Town of Rolesville
502 Southtown Circle
PO Box 250
Rolesville, North Carolina 27571

RE: Frazier Farm Park CDs
Case Number: V3-CID-23-05
Response to 3rd TRC Review Comments
ROL-2020110039

Sheet C6.01 Overall Erosion Control Plan Stage I

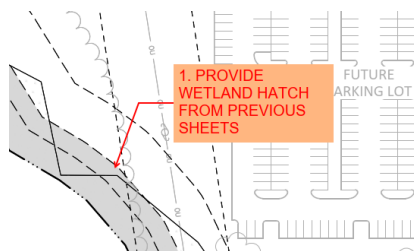
7. Due to grading in this area please provide silt fence to protect area beyond LOD. Match the silt fence locations from "Street A". Please see sheet C7.00 for enlarged reference.

McAdams Response: The silt fence has been updated to match the locations shown.

Sheet 2.01 Site Plan: Area 'A'

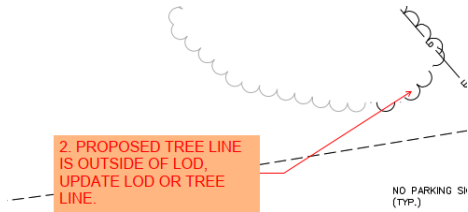
10.

McAdams Response: Proposed tree line has been updated to stay inside the limits of disturbance. See McAdams response to comment 3.

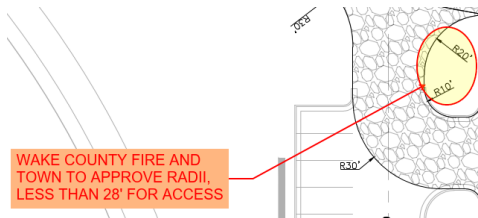
11.

McAdams Response: Right turn in radius has been updated to 28' for fire truck access.

Sheet C2.02 Site Plan: Area 'B'

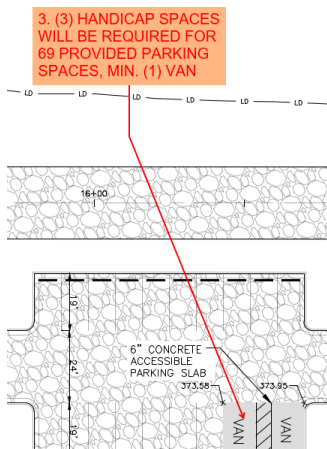
12.

McAdams Response: A third ADA space has been added to adhere to ADA requirements. See McAdams response to comment 4.

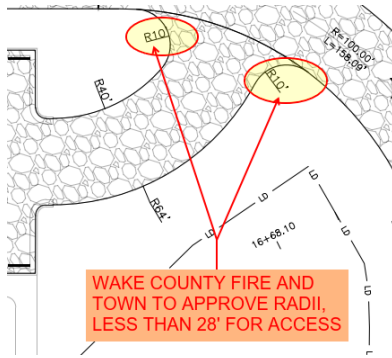
13.

McAdams Response: Radii have been adjusted in direction of travel for fire truck access. Future modifications may be required at time of full buildout.

Sheet C3.01 Grading & Drainage Plan: Area 'A'

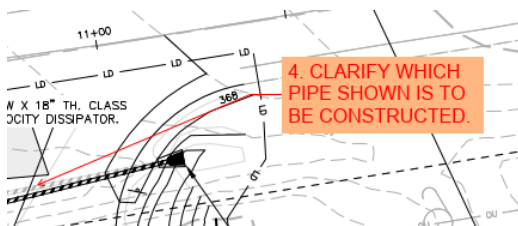
14.

McAdams Response: Plan set has been updated to show only the pipe being constructed. See McAdams response to comment 5.

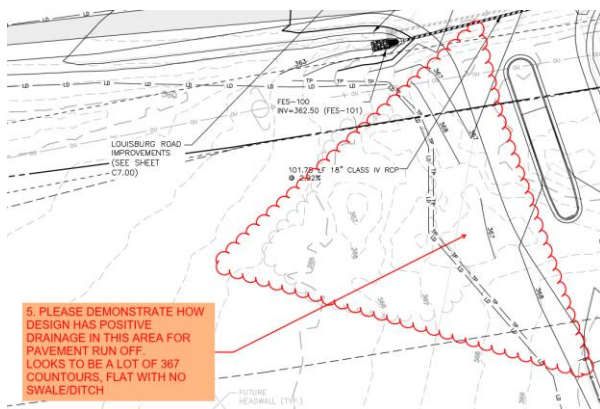
15.

McAdams Response: Contours have been adjusted to show positive drainage toward roadside swale and graded depression at future field swale.

Sheet C6.01 Overall Erosion Control Plan – Stage I

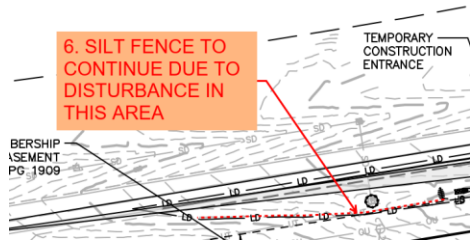
16.

McAdams Response: Silt fence has been updated to reflect the disturbance in the outlined area.

Sheet XXX Erosion Control Details

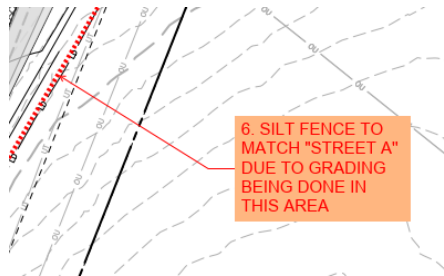
17.

7. sheet #

McAdams Response: Sheet numbers have been added for all erosion control detail pages. See McAdams response to comment 8.

Sheet C2.01 Site Plan: Area 'A'

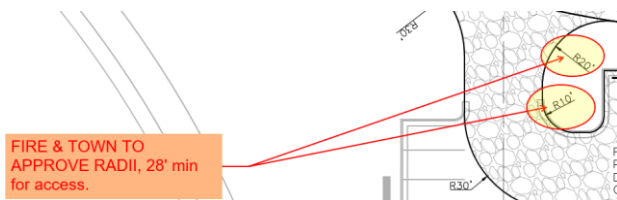
19.

McAdams Response: Radii have been increased to allow for fire truck access.

Sheet C6.01 Overall Erosion Control Plan – Stage I

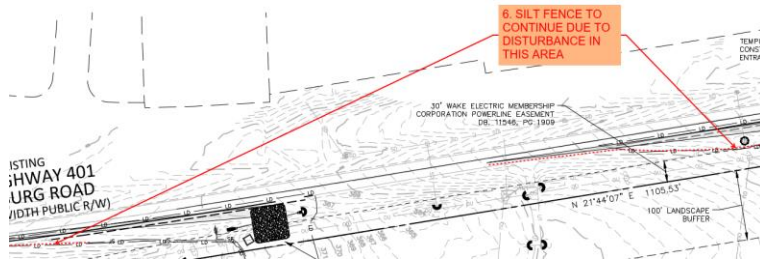
20.

McAdams Response: Silt fence has been updated to reflect the disturbance in the outlined area.

C7.00 Louisburg Rd Widening Plan

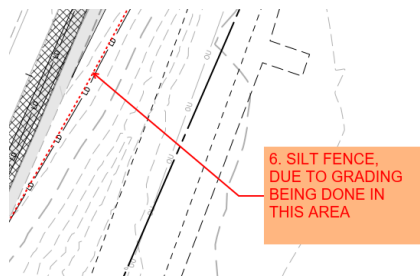
21.

McAdams Response: Silt fence has been updated to reflect the grading done in the outlined area.

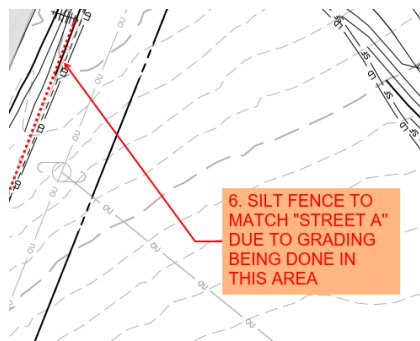
22.

McAdams Response: Silt fence has been updated to match "Street A" from grading being done within the outlined area.
